Project	IEEE 802.16 Broadband Wireless Access Working Group < http://ieee802.org/16 >	
Title	In-band Transparent Relay Frame Structure	
Date Submitted	2006-03-05	
Source(s)	<p>Kanchei (Ken) Loa, Yi-Hsueh Tsai, Yung-Ting Lee, Heng-Iang Hsu, Shiann-Tsong Sheu, Frank C.D. Tsai, Youn-Tai Lee, Chih-Chiang Hsieh, Hua-Chiang Yin, Institute for Information Industry 8F., No. 218, Sec. 2, Dunhua S. Rd., Taipei City, Taiwan.</p> <p>Gang Shen, Kaibin Zhang Alcatel-Lucent, Research & Innovation 388#, Ningqiao Road, Shanghai, China.</p> <p>[add co-authors here]</p>	<p>Voice: +886-2-2739-9616 loa@iii.org.tw</p> <p>gang.a.shen@alcatel-sbell.com.cn</p>
Re:	IEEE 802.16j-07/007r2: "Call for Technical Comments and Contributions regarding IEEE Project 802.16j"	
Abstract	This contribution proposes in-band transparent relay frame structure	
Purpose	Text proposal for 802.16j Baseline Document	
Notice	This document has been prepared to assist IEEE 802.16. It is offered as a basis for discussion and is not binding on the contributing individual(s) or organization(s). The material in this document is subject to change in form and content after further study. The contributor(s) reserve(s) the right to add, am

Figure xxx Example of configuration for an in-band transparent relay frame structure

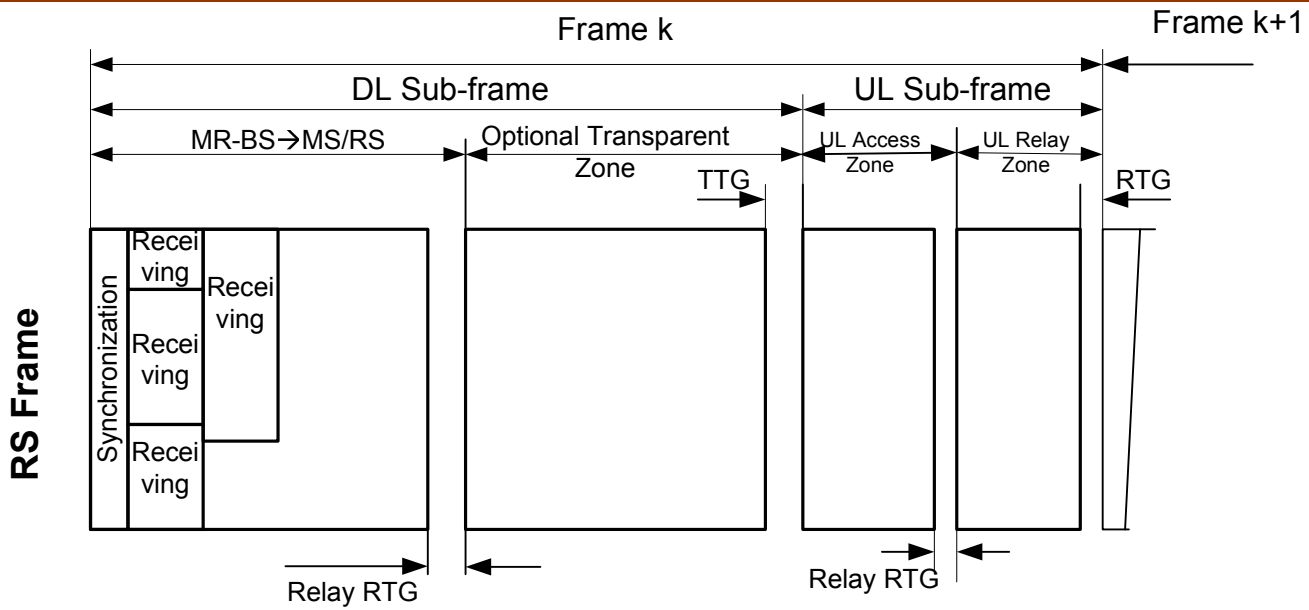
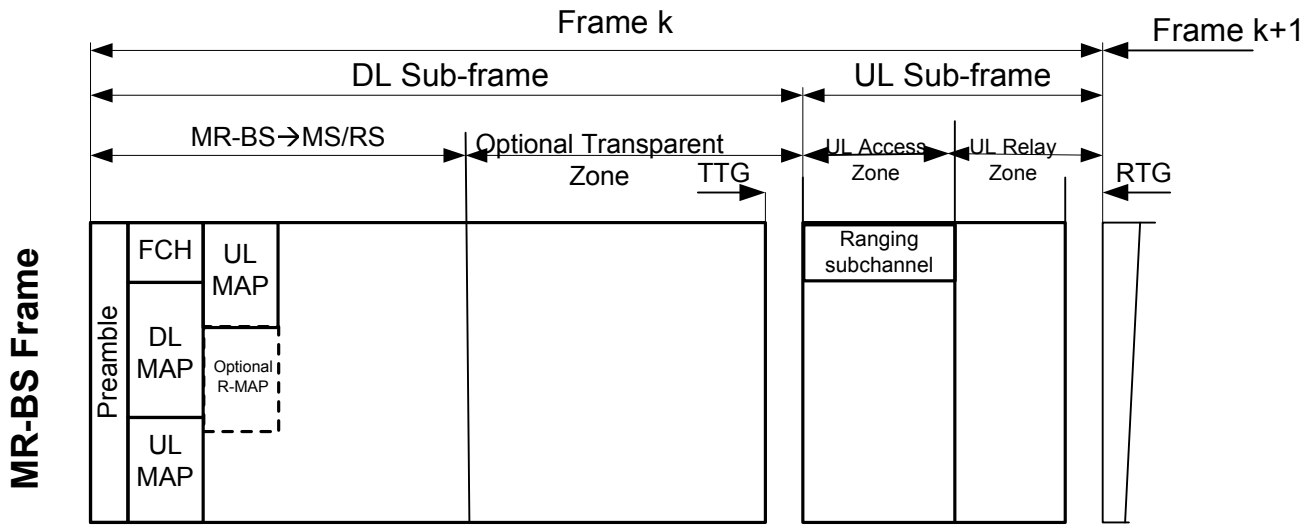
[Change the figure in section 8.4.4.7.1 “Frame structure for transparent mode” as indicated:]

[Replace Figure xxx with Figure yyy-a and Figure yyy-b as follows:]
